CRMC DECISION WORKSHEET

2026-05-006

STATE OF RHODE ISLAND
COASTAL RESOURCES MANAGEMENT COUNCIL
STAFF REPORT TO THE COUNCIL

Applicant's Name:	Westerly Municipal Land Trust
CRMC File Number:	2026-05-006
Project:	Construct a parking space and walking path terminating at wetland edge; mark Buffer Zone
Location:	32 Harbor Drive; Westerly: Plat(s): 154; Lot(s): 22
Water Type/Name:	Type 2, Winnapaug Pond
Coastal Feature:	Coastal Pond backed by Coastal Wetland
Plans Reviewed:	"32 Harbor Drive, Westerly... Site Plan..." one sheet by Al DiOrio dated April 30, 2014 and last revised 9/3/2026

Above: Portion of plan showing proposed work

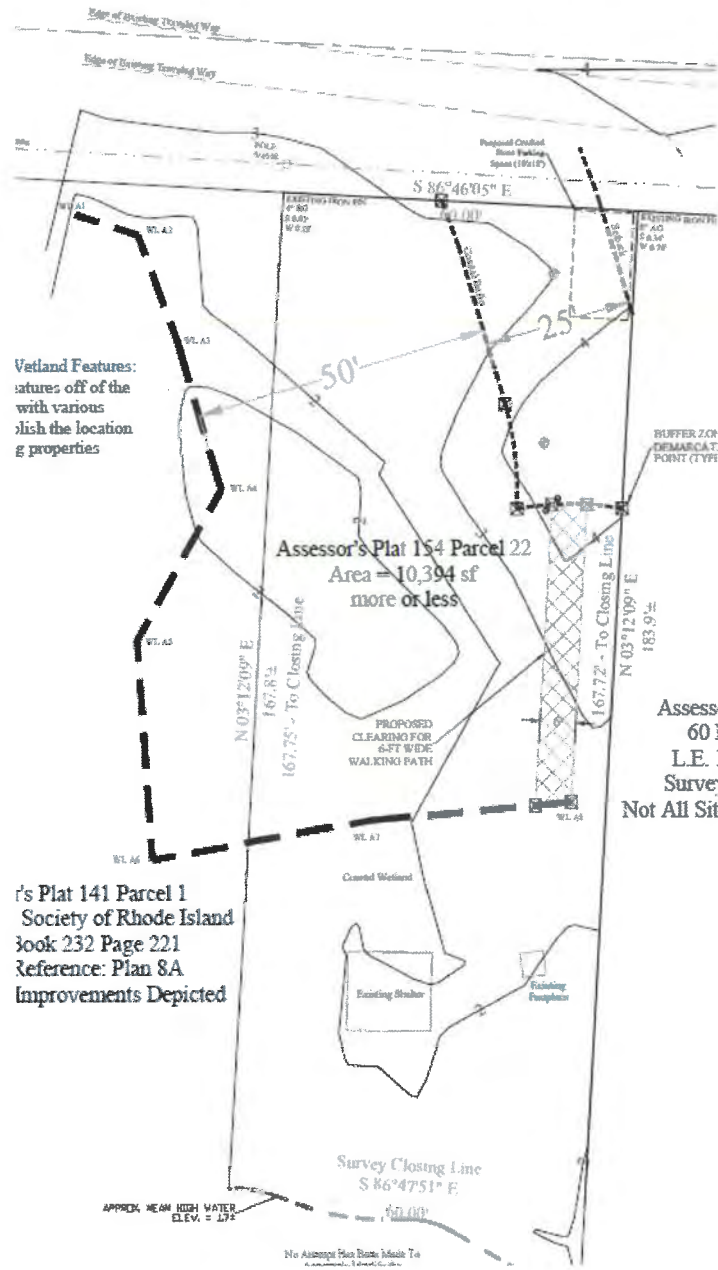
The town then submitted plans from 2014 which included a wooden boardwalk over the wetland. The submitted building official form did not reference construction of the boardwalk, and one of the proposed parking spaces was within the Buffer, so staff requested Building official sign-off as well as a Variance request for the minor intrusion into the Buffer. Town engineer responded that the boardwalk was not being requested at this time, and staff asked for a clean plan depicting only what was being requested currently.

The revised plan removed a path entirely, and staff questioned if the proposal still included a walking path, which would be required to terminate at the wetland edge. The Town responded yes, and provided a new plan that depicted the parking area, a 6' path terminating at the wetland edge, and permanent Buffer Zone markers.

The original 2014 plan showed multiple parking spots, which would have required a small reduction in the 50 foot Buffer. Staff noted this to the Town and suggested that Buffer Markers and a Variance request be submitted. The Town revised the plan to eliminate all Variances.

One objection notes that a 6' path does not allow for proper emergency access. A 6' foot path is standard with for all paths within Buffer Zones, and is frequently the width of public ROW access paths as well. The subject property is being reviewed as a "residential property" and has all residential Buffer Zone regulations and guidelines applied.

Concerns have been raised about removal of vegetation. A lot of this size on Type 2 Water requires a 50 foot Buffer Zone (Section 1.1.11 Table 4). The entire 50 foot Buffer Zone shall be retained and marked with permanent markers. Areas outside the Buffer may be cut with CRMC Assent.
